CITY OF ALBUQUERQUE

February 1, 2021

**RE: The Strider
109 Vassar Dr SE
Conceptual Grading and Drainage Plan
Engineer's Stamp Date: 01/08/21
Hydrology File: K16D022A**

PROJECT
109 VASSAR DRIVE S.E. REDEVELOPMENT
133 VASSAR DRIVE S.E.
ALBUQUERQUE NM 87106
TITLE
CONCEPTUAL GRADING PLAN

C100

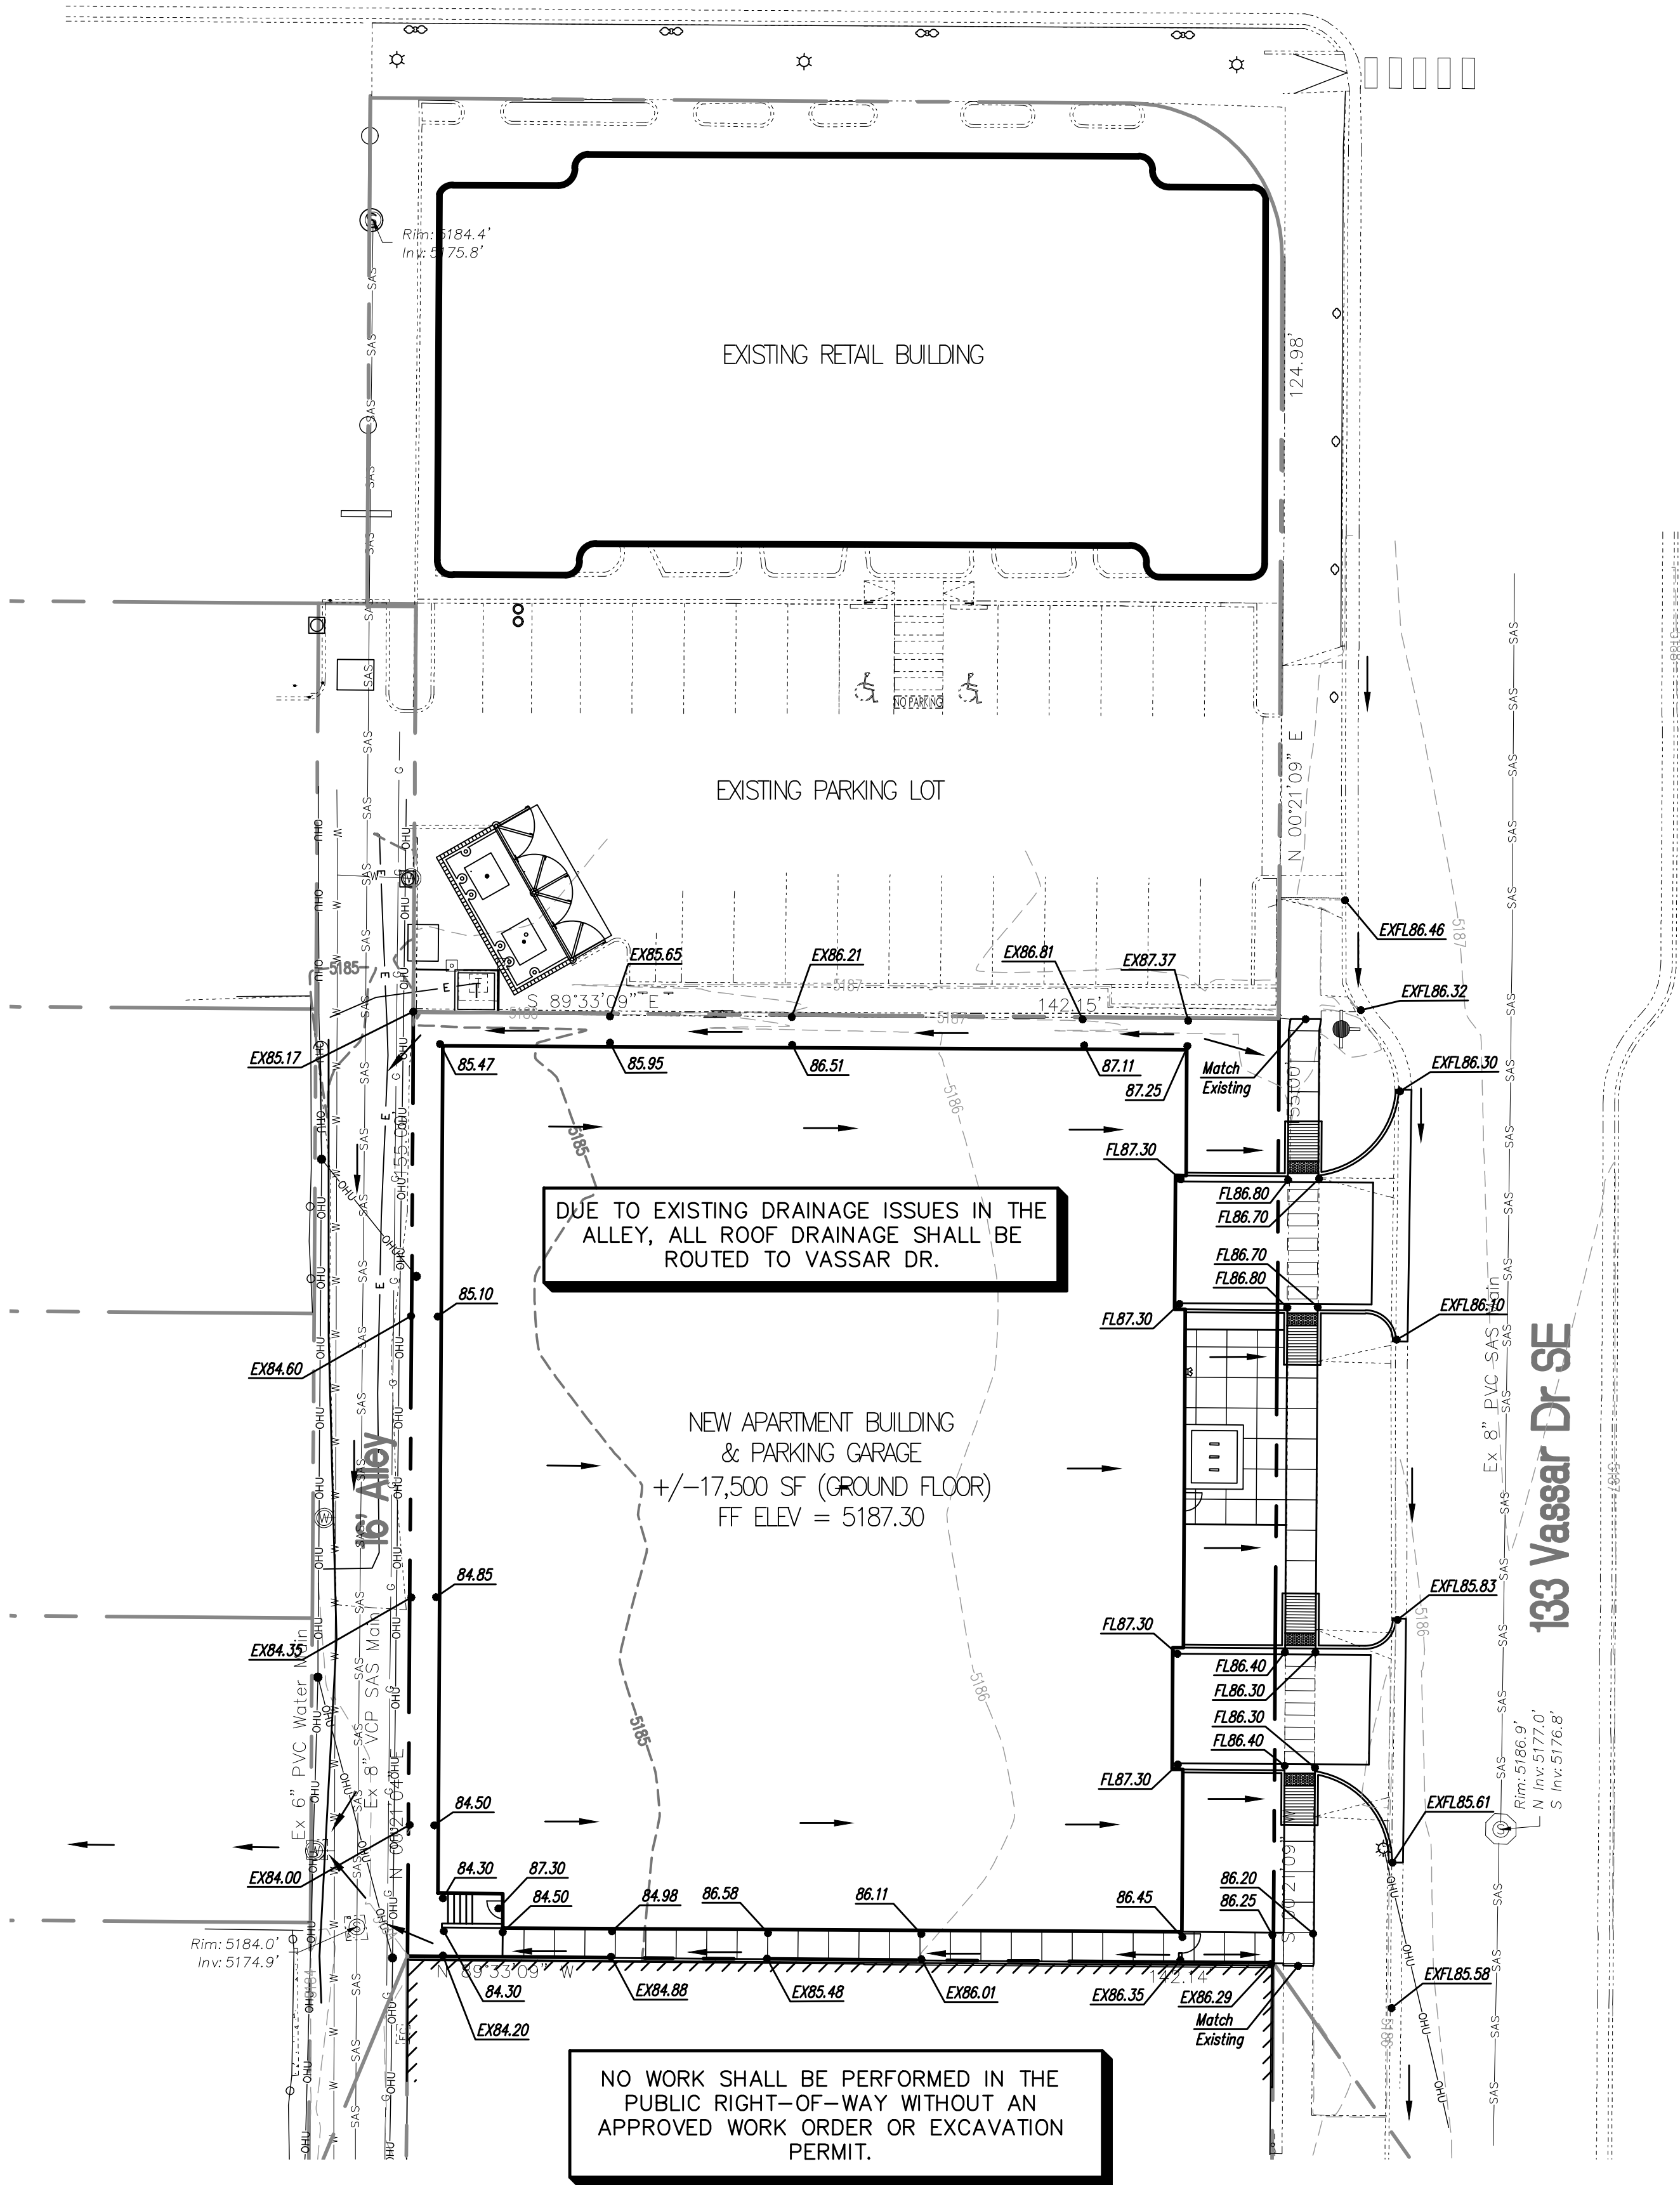
Based upon the information provided in your submittal received 01/08/2021, the Conceptual Drainage Report is approved for action by the DRB on Site Plan for Building Permit.

If the project total area of disturbance (including the staging area and any work within the adjacent Right-of-Way) is 1 acre or more, then an Erosion and Sediment Control (ESC) Plan and Owner's certified Notice of Intent (NOI) is required to be submitted to the Stormwater Quality Engineer (Doug Hughes, PE, jhughes@cabq.gov, 924-3420) 14 days prior to any earth disturbance.
